Amendments to Design Manual: Barrier Free Access 2008

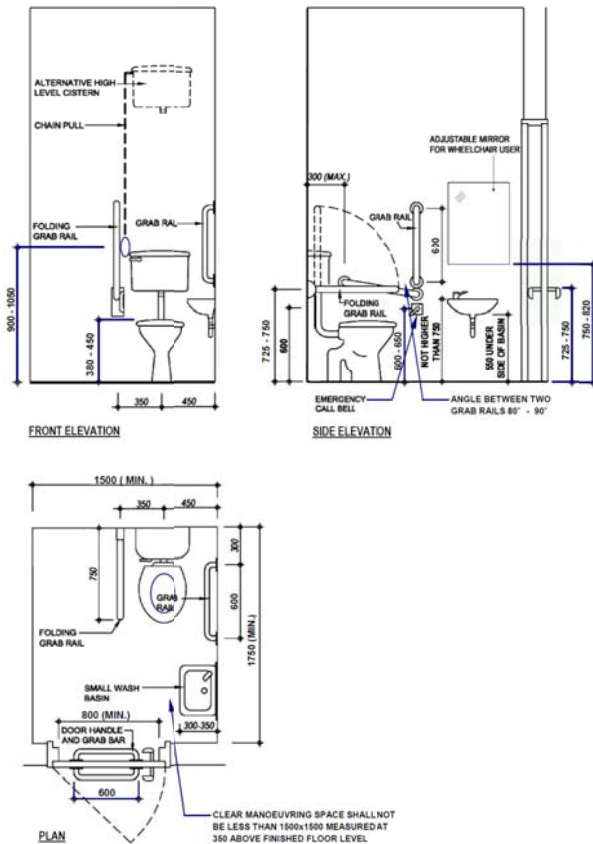
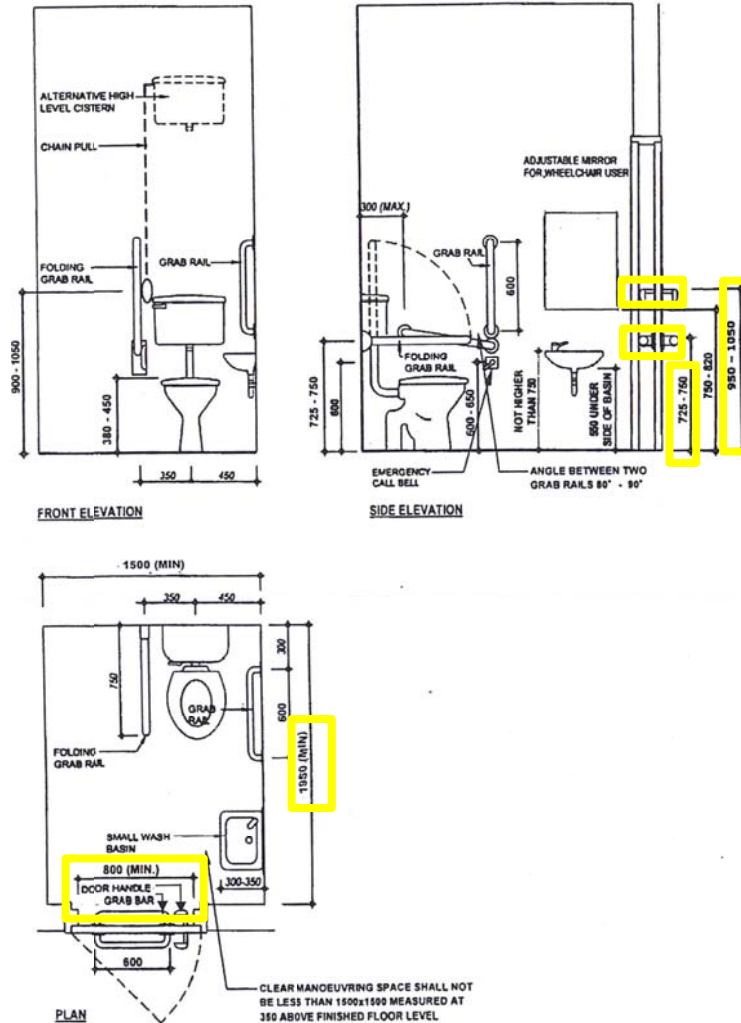
Item	2008 version	Amendments
<p>2. Figure 16B (Paragraph B(b) in Division 8)</p>	 <p data-bbox="571 833 743 849">*ALL DIMENSIONS ARE IN mm</p> <p data-bbox="696 895 913 911">Figure 16B - Handrail in Recess</p>	 <p data-bbox="1496 1152 1668 1168">*ALL DIMENSIONS ARE IN mm</p> <p data-bbox="1496 1198 1727 1214">Figure 16B - Handrail in Recess</p>

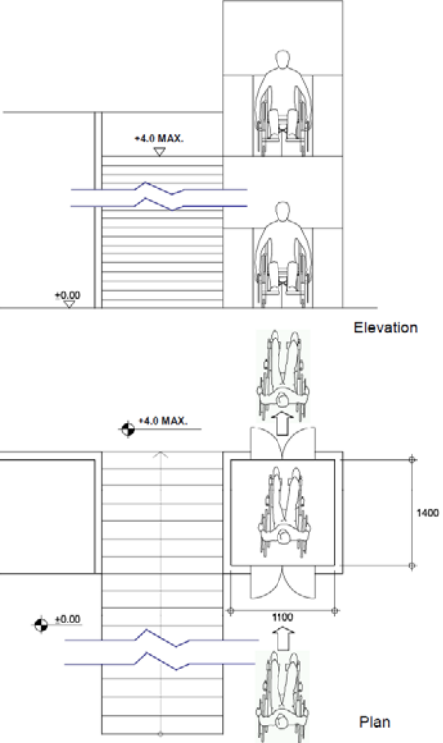
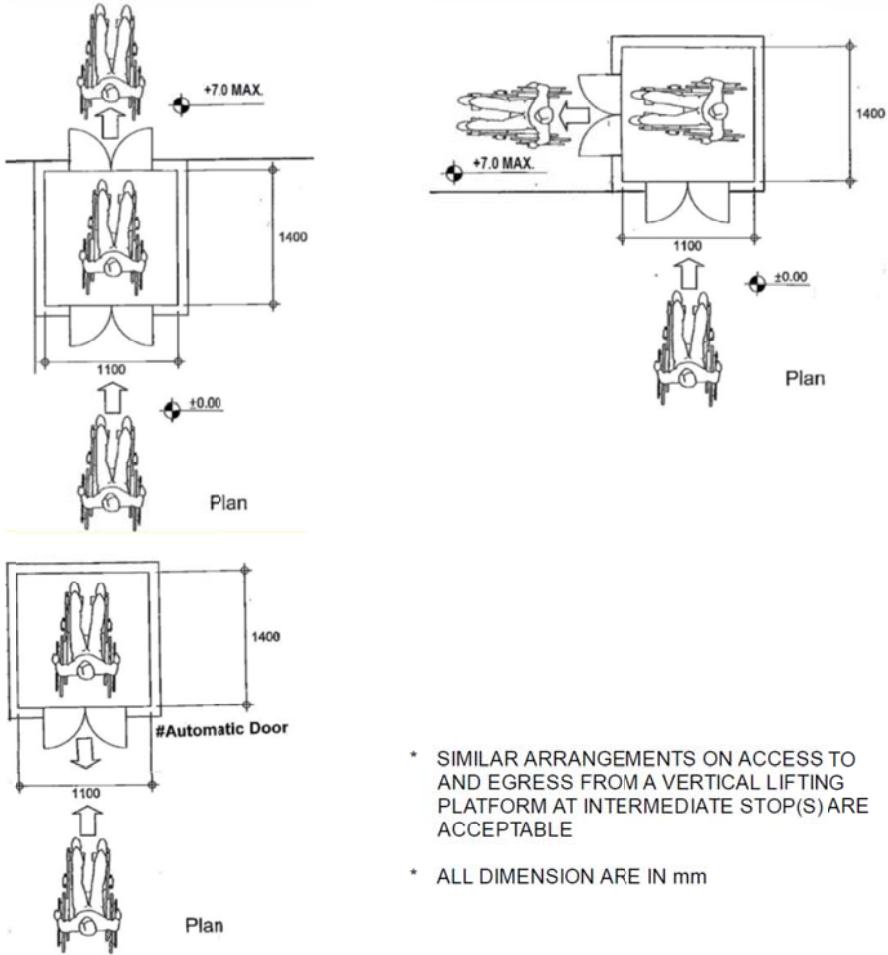
Item	2008 version	Amendments
10. Figure 45	 <p data-bbox="533 991 705 1007">*ALL DIMENSIONS ARE IN mm</p> <p data-bbox="577 1034 817 1050">Figure 45 – Vertical Lifting Platform</p>	 <p data-bbox="1601 970 2072 1066">* SIMILAR ARRANGEMENTS ON ACCESS TO AND EGRESS FROM A VERTICAL LIFTING PLATFORM AT INTERMEDIATE STOP(S) ARE ACCEPTABLE</p> <p data-bbox="1601 1090 1904 1114">* ALL DIMENSION ARE IN mm</p> <p data-bbox="1411 1220 1825 1252">Figure 45 – Vertical Lifting Platform</p>
